SEWAGE DISPOSAL TESTING

MARYLAND STATE DEPARTMENT OF HEALTH

SUBDIVISION Mt. Hebron, Inc. LOT NO. 101, Sec. 11

ROAD AND DESCRIPTION Calvin Circle

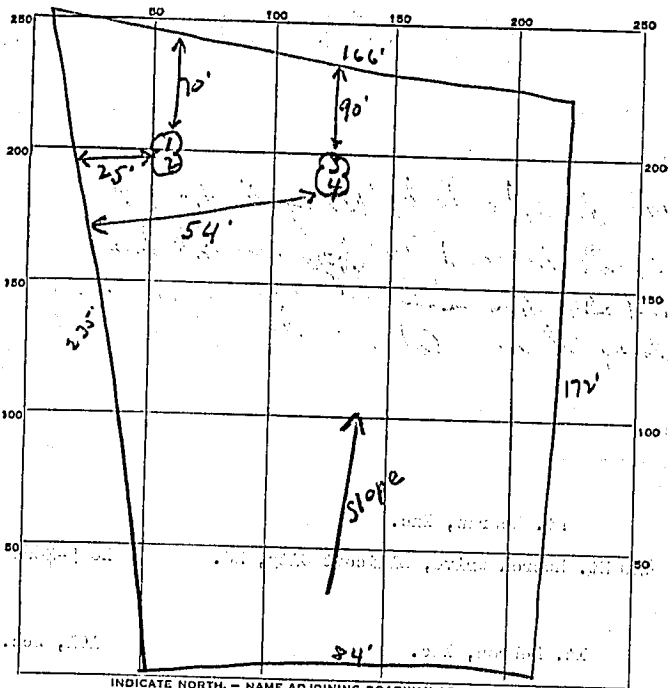
*1000 gal. septic tank, 400 sq. ft. dry-well
locate dry-well 90' from rear lot line
and 54' from left lot line, as seen in plan
facing lot from Calvin Circle. inlet depth may have to be
3 1/2 to 4' deep 7'
before effective area starts*

APPROVED BY Robert F. Palmer FOR dry-well DATE 9/24/70
(KIND OF SYSTEM)

REMARKS: Use hole 3-4
